DELAMAR WEST HARTFORD

COOLING TOWER

ASK-43a

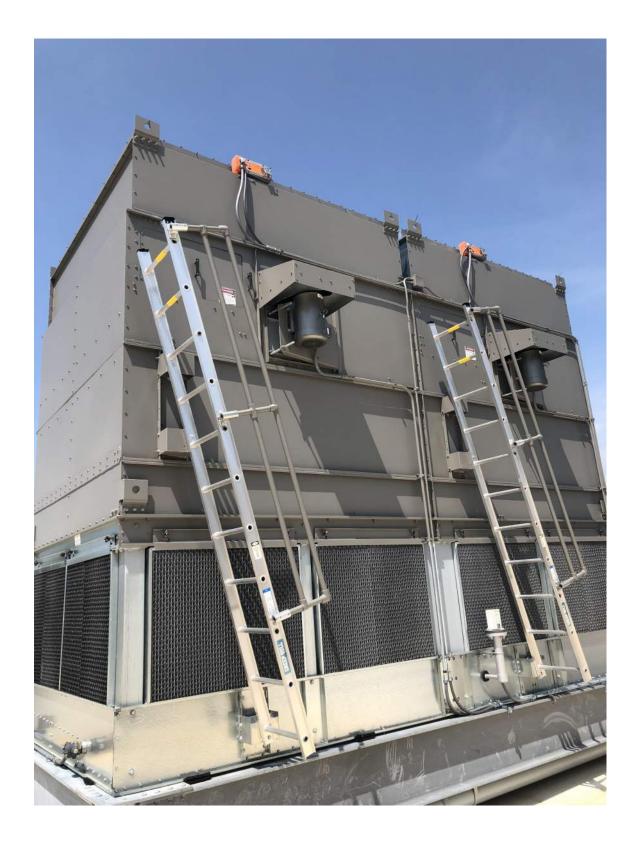
LADDERS AND LADDER ATTACHMENT POINTS REMOVED
CRANE ATTACHMENT POINTS REMOVED
PAINT ACCESSORIES PREVIOUSLY UNPAINTED
ENCLOSE FAN MOTORS IN LOUVERED SHEETMETAL HOUSING
ALL PAINTED TO MATCH METAL ROOF COLOR

LADDERS AND LADDER ATTACHMENT POINTS REMOVED CRANE ATTACHMENT POINTS REMOVED PAINT ACCESSORIES PREVIOUSLY UNPAINTED ENCLOSE FAN MOTORS IN LOUVERED SHEETMETAL HOUSING ALL PAINTED TO MATCH METAL ROOF COLOR
